- A. **PRELIMINARY SITE PLAN – FROST MUSIC VENUE – 2525 STATE STREET – PARCEL K-11-13-255-004 & 1430 WATSON STREET – PARCEL K-11-13-255-006 – TO CONSIDER THE PRELIMINARY SITE PLAN APPLICATION OF BLOOM GENERAL CONTRACTING, INC. FOR THE CONSTRUCTION OF A 4,300 SQ. FT. MARIHUANA CONSUMPTION LOUNGE, 1,260 SQ. FT. STORAGE BUILDING, AND OUTDOOR AMPITHEATER FOR A 3.6-ACRE SITE ZONED I-C, INDUSTRIAL AND COMMERCIAL.**

**YPSILANTI
TOWNSHIP**
— PLANNING & ZONING DEPARTMENT —

Action Requested: Preliminary Site Plan Approval

The Office of Community Standards is in receipt of a Preliminary Site Plan Application from Frost Music Venue representative Michael Ludtke, for a proposed 4,300 sq. ft. marihuana consumption lounge, 1,260 sq. ft. storage building, and outdoor amphitheater. The plans include associated site utilities, lighting, parking, drive-lanes, and pedestrian walks. The proposed project is affiliated with an existing development to the north: Frost Dispensary & Cultivation Center.

Drawn by :
 Author
 Checked by :
 Checker
 Sheet Title :
 ARCHITECTURAL SITE DETAILS

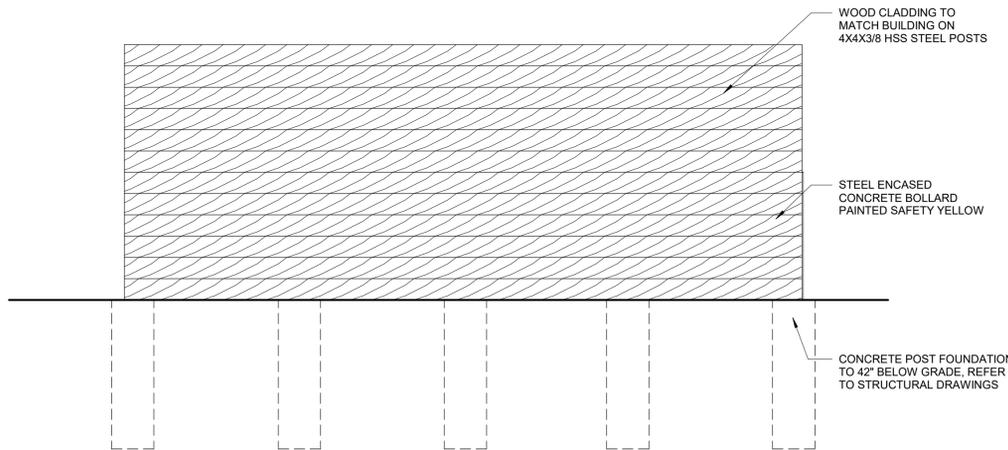
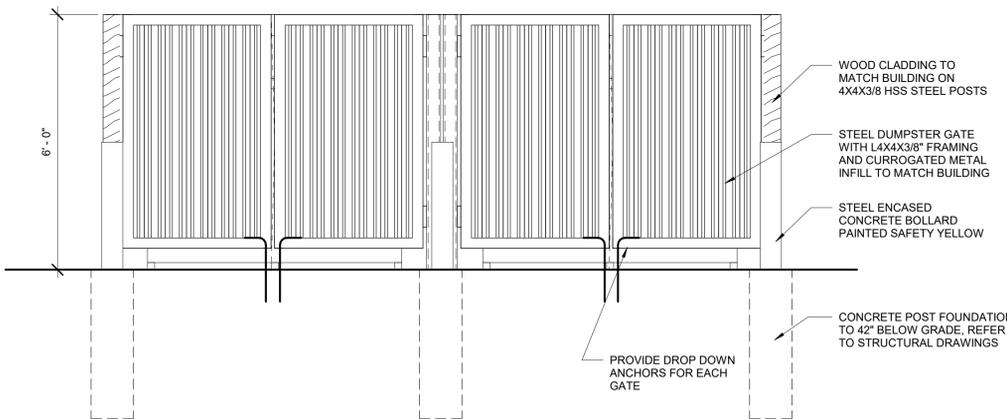
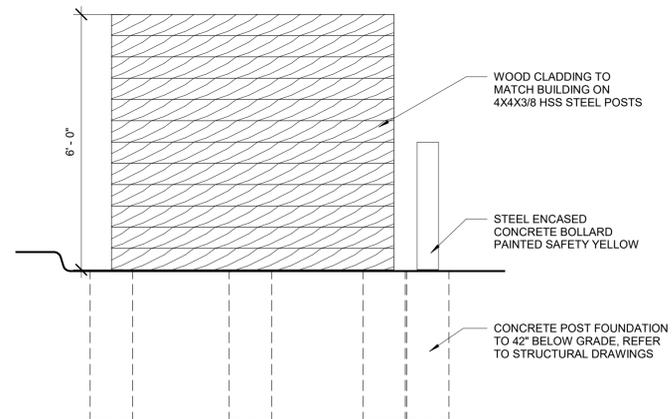
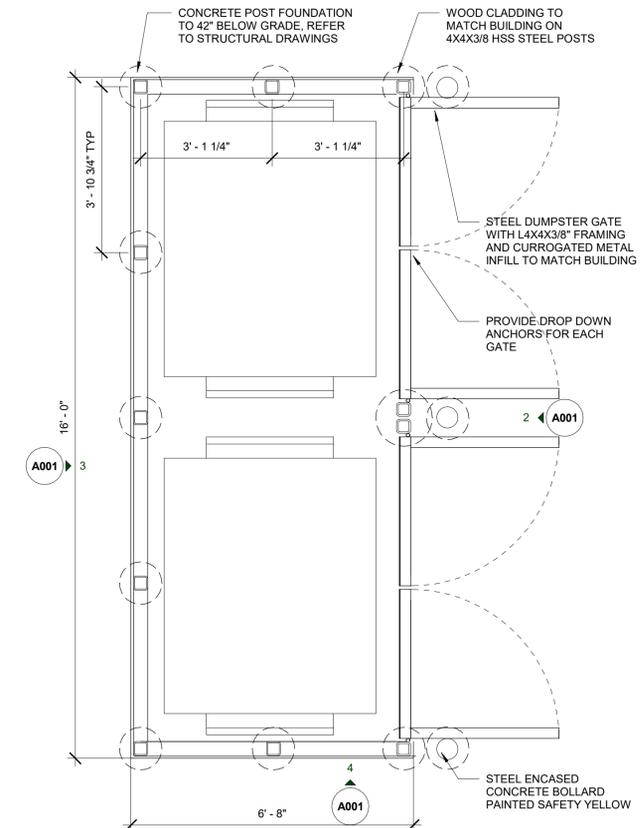
- 1) *Provide trash enclosure screening details.*

- 1) *Applicant shall provide canopy elevation and material details for canopy, retaining wall, and seating area.*

8. As noted in above item #7, a dumpster enclosure has been added, and a garbage truck turning maneuver is provided on sheet C03.

EXHIBIT 4
SOUND LEVEL CONTOUR PLOT OF MUSIC FROM THE PROPOSED FROST AMPHITHEATER WITH
OPEN STAGE FACING TOWARD THE EAST-SOUTHEAST

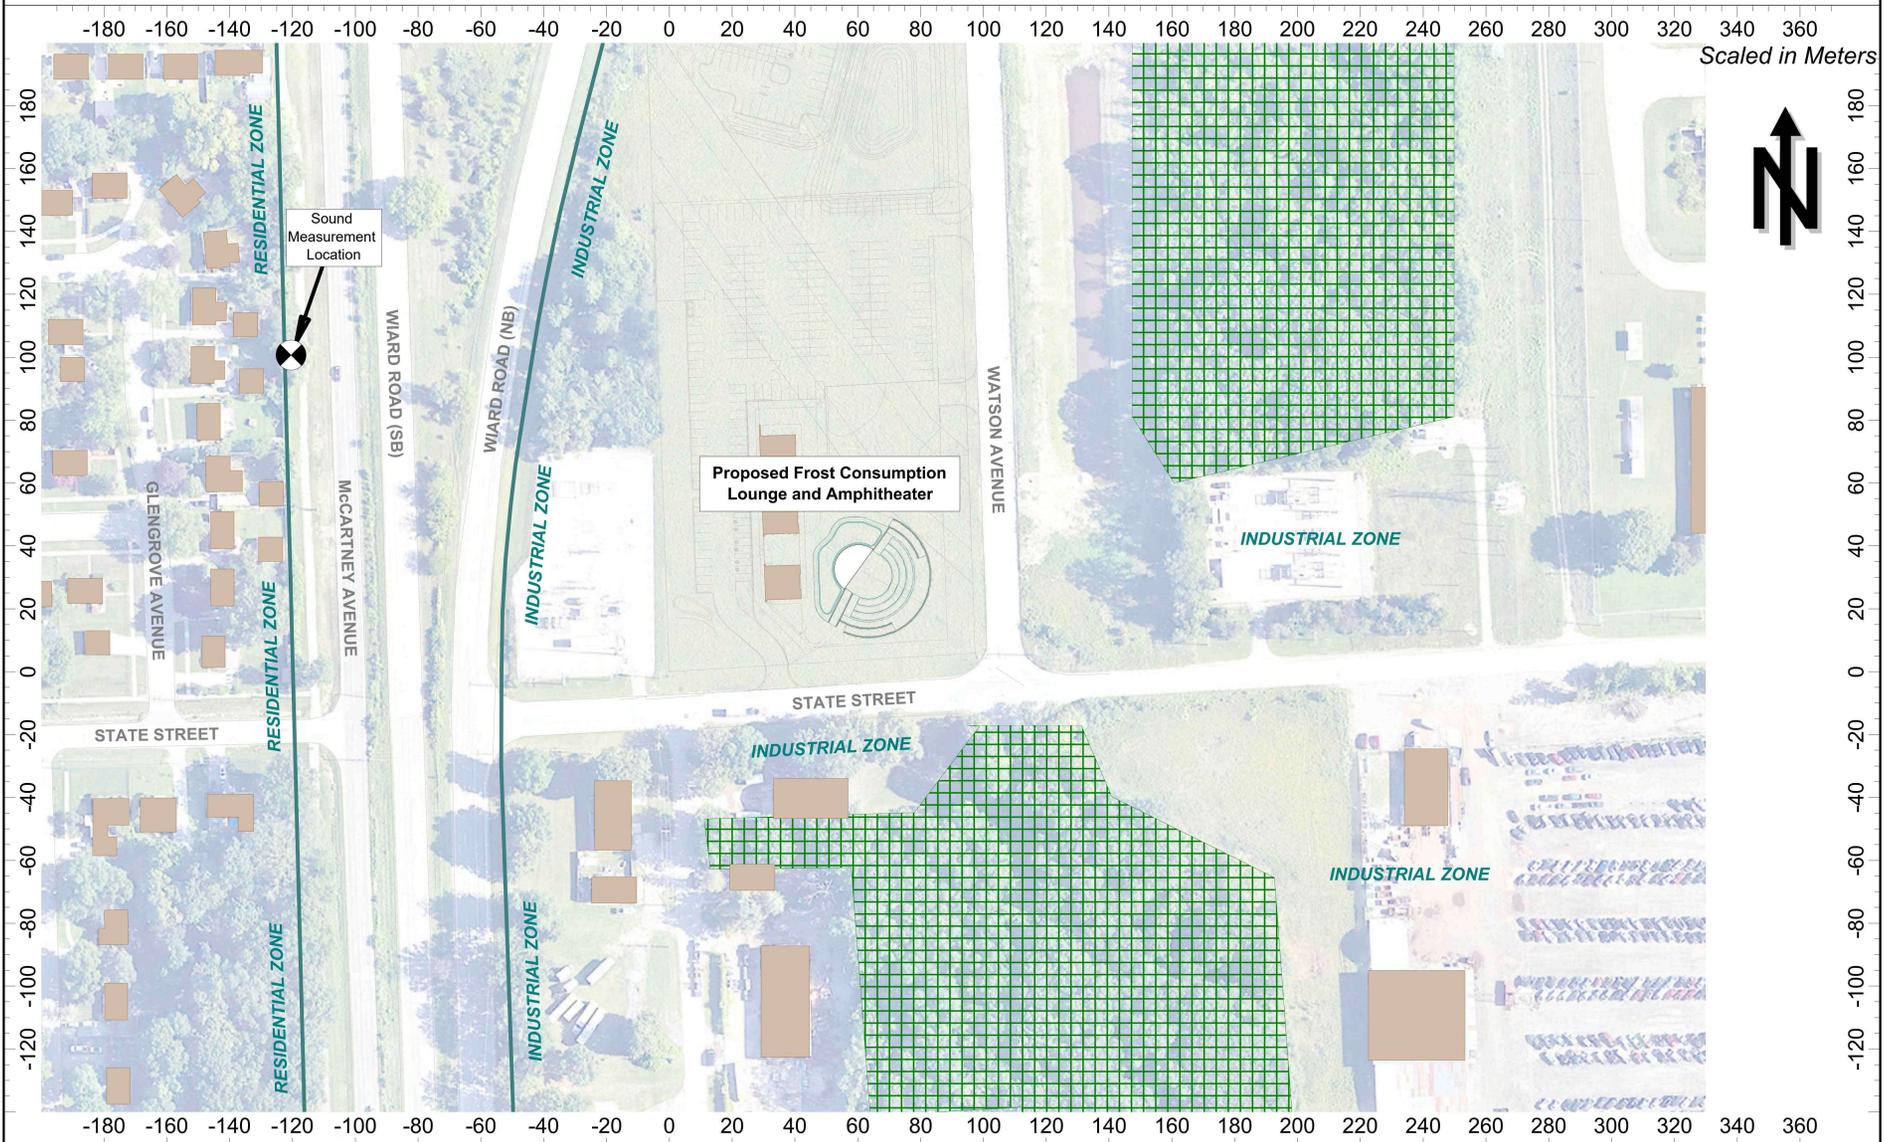
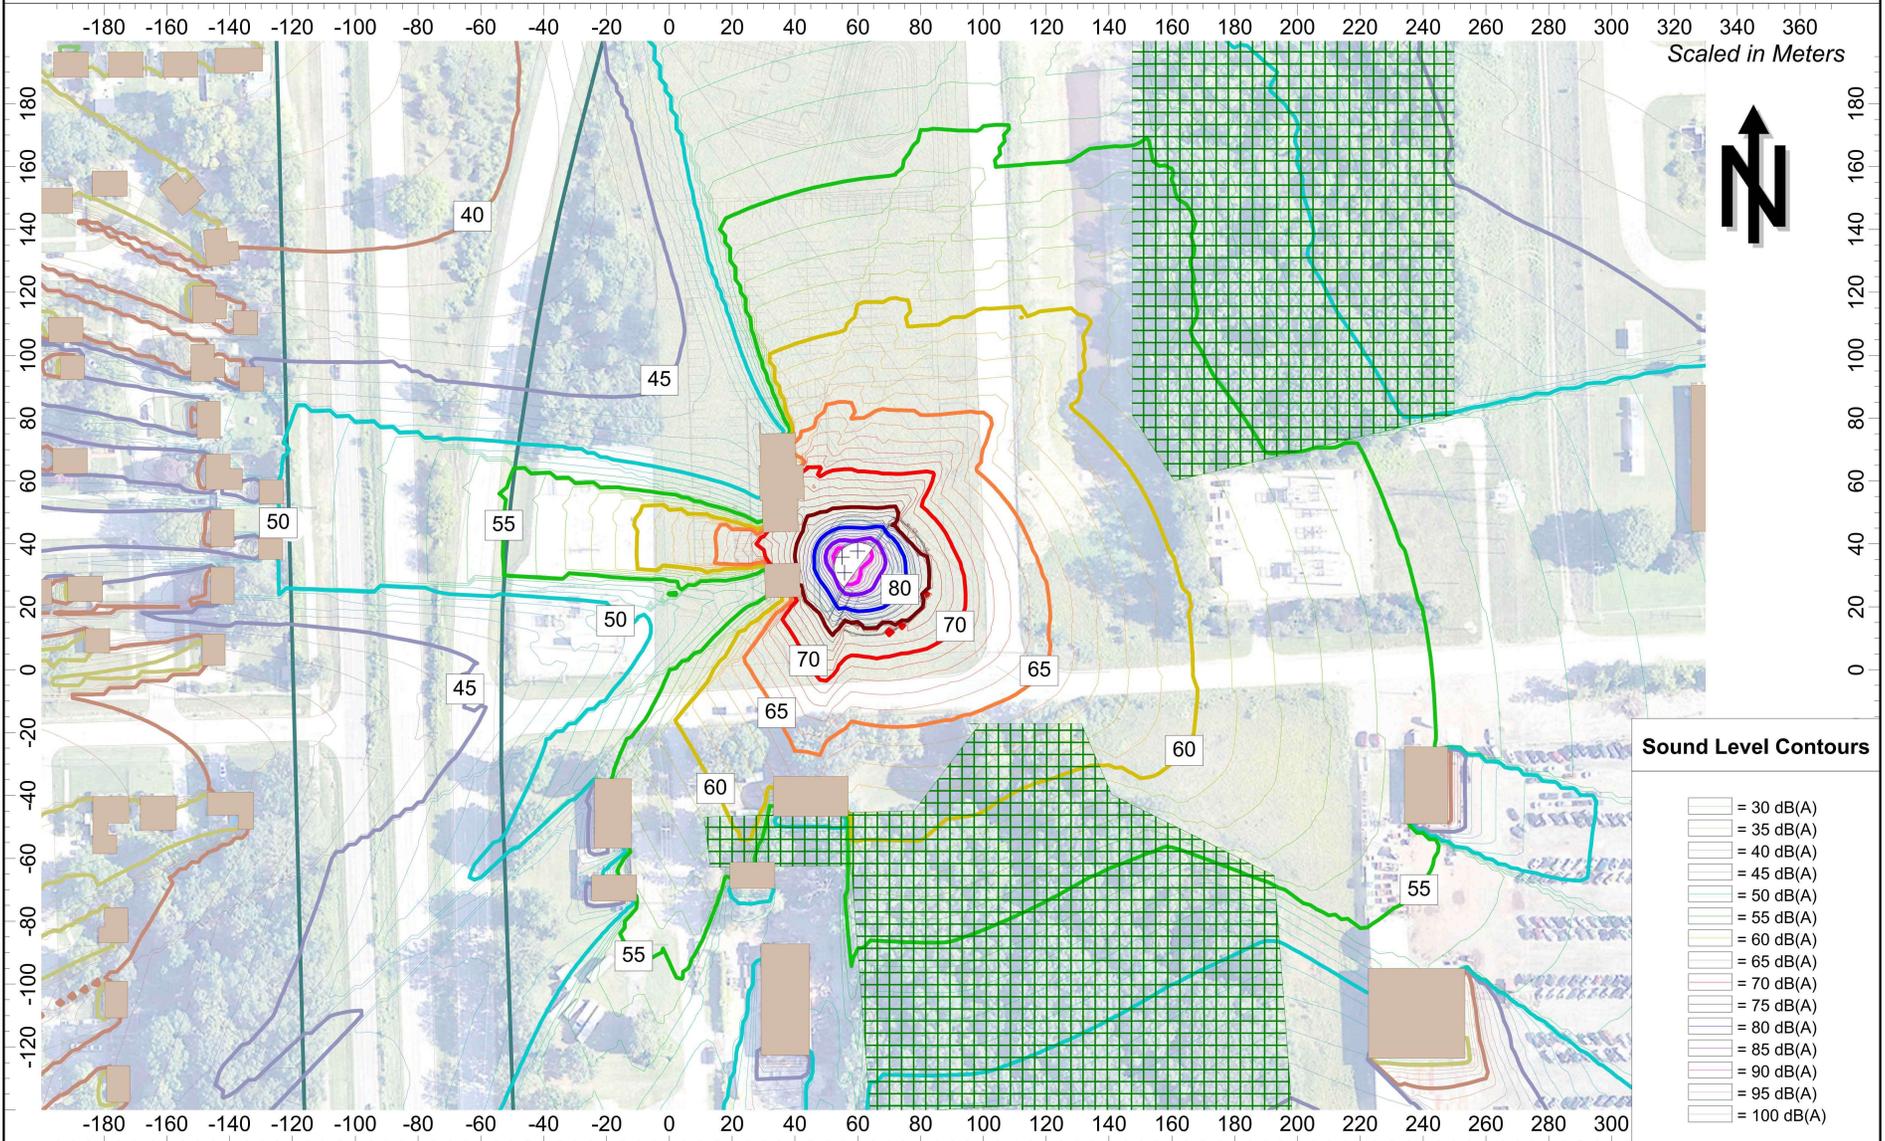
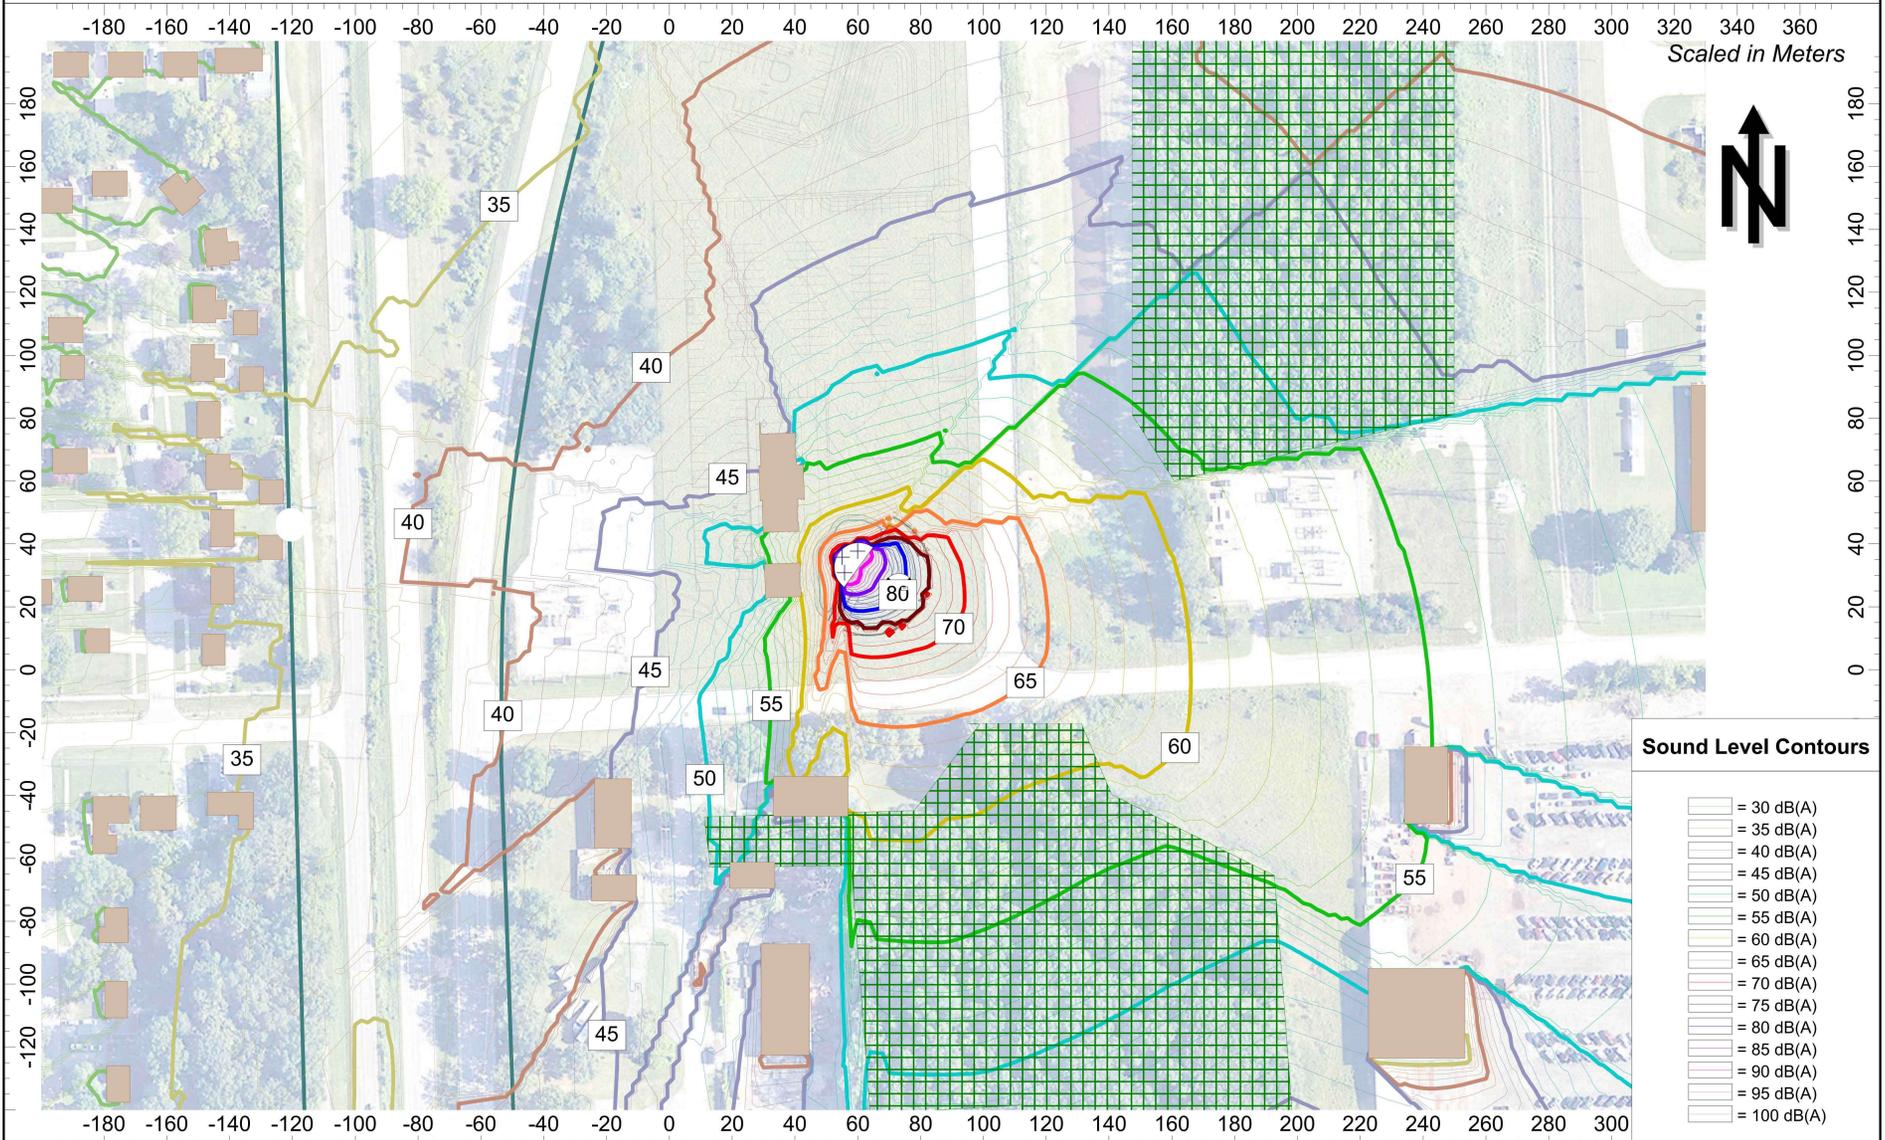
- 1) *Planning Commission shall have applicant discuss conclusions of noise study.*
- 2) *Planning Commission and Staff shall confirm that a bandshell is proposed.*

The results of this the model with the optional bandshell are provided in **EXHIBIT 5**. With the addition of the bandshell, sound levels at the residents to the west is expected to be less than 40 dB(A). This lower level will provide additional buffer to the residents and provide a wider tolerance range for the varying music sound levels relative to the ordinance noise limits.
